**TYPICAL SECTION ALTERNATE A**  
 VT ROUTE 100C MM 0.025 (JOHNSON) - MM 0.928 (JOHNSON)  
 VT ROUTE 100C MM 0.044 (HYDE PARK) - MM 0.087 (HYDE PARK)  
 VT ROUTE 118 MM 5.565 (MONTGOMERY) - MM 1.565 (BERKSHIRE)

**TYPICAL SECTION ALTERNATES B & C**  
 VT ROUTE 100C MM 0.025 (JOHNSON) - MM 0.928 (JOHNSON)  
 VT ROUTE 100C MM 0.044 (HYDE PARK) - MM 0.087 (HYDE PARK)  
 VT ROUTE 118 MM 5.565 (MONTGOMERY) - MM 1.565 (BERKSHIRE)

PROJECT NAME: JOHNSON - HYDE PARK, BELVIDERE - BERKSHIRE
PROJECT NUMBER: STP SURF(52), STP SURF(53)
FILE NAME: I4v204\p14v204.dgn\p14v204_05.I PLOT DATE: 26-JAN-2016
PROJECT LEADER: M. FOWLER DRAWN BY: K. LOCKE
DESIGNED BY: K. LOCKE CHECKED BY: M. FOWLER
TYPICAL SECTIONS SHEET 2 SHEET 5 OF 45

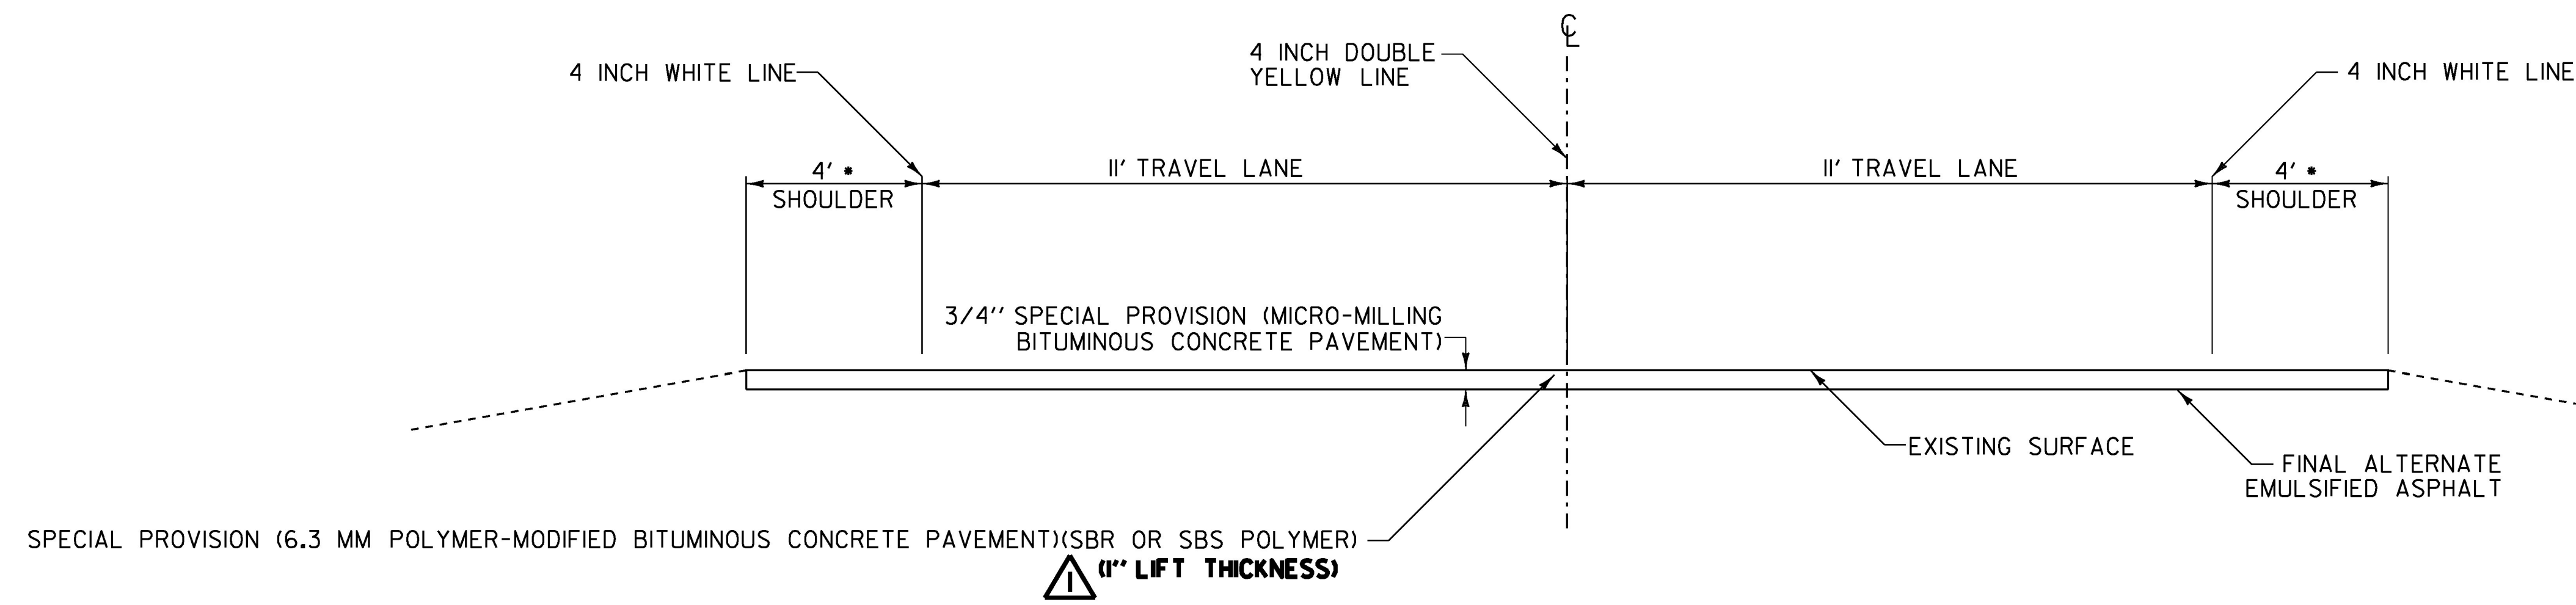
REVISION	DATE	DESCRIPTION	BY
1	01-26-16	LIFT THICKNESS CHANGED FROM 5/8" - 3/4" TO 3/4". ADDED THICKNESS TOLERANCE NOTE.	KML

**NOTE:**  
 1. SPECIAL PROVISION (PAVER PLACED SURFACE TREATMENT, TYPE C) (3/4" LIFT THICKNESS) PAVEMENT TOLERANCE = +/- 1/8 INCH (TOTAL THICKNESS).  
 • 4' SHOULDER WIDTH WILL BE APPLICABLE IN MOST AREAS. IN AREAS WHERE THE SHOULDER IS LESS THAN OR EXCEEDS 4' IN WIDTH THE CONTRACTOR SHALL FOLLOW THE EXISTING SHOULDER WIDTH.

REVISION	DATE	DESCRIPTION	BY
1	01-27-16	LIFT THICKNESS CHANGED FROM 3/4" - 1" TO 1". ADDED THICKNESS TOLERANCE NOTE.	KML

**NOTES:**  
 1. PRIOR TO THE PLACEMENT OF THE POLYMER-MODIFIED BITUMINOUS CONCRETE PAVEMENT, EMULSIFIED ASPHALT SHALL BE APPLIED TO ALL EXISTING PAVEMENT SURFACES AND ON ALL MICRO-MILLED SURFACES AT A RATE OF 0.080 GAL/SY (+/- 0.01GAL/SY) OR AS DIRECTED BY THE ENGINEER.  
 2. SPECIAL PROVISION (6.3 MM POLYMER - MODIFIED BITUMINOUS CONCRETE PAVEMENT) (SBR OR SBS POLYMER) (1" LIFT THICKNESS) PAVEMENT TOLERANCE = +/- 1/8 INCH (TOTAL THICKNESS).
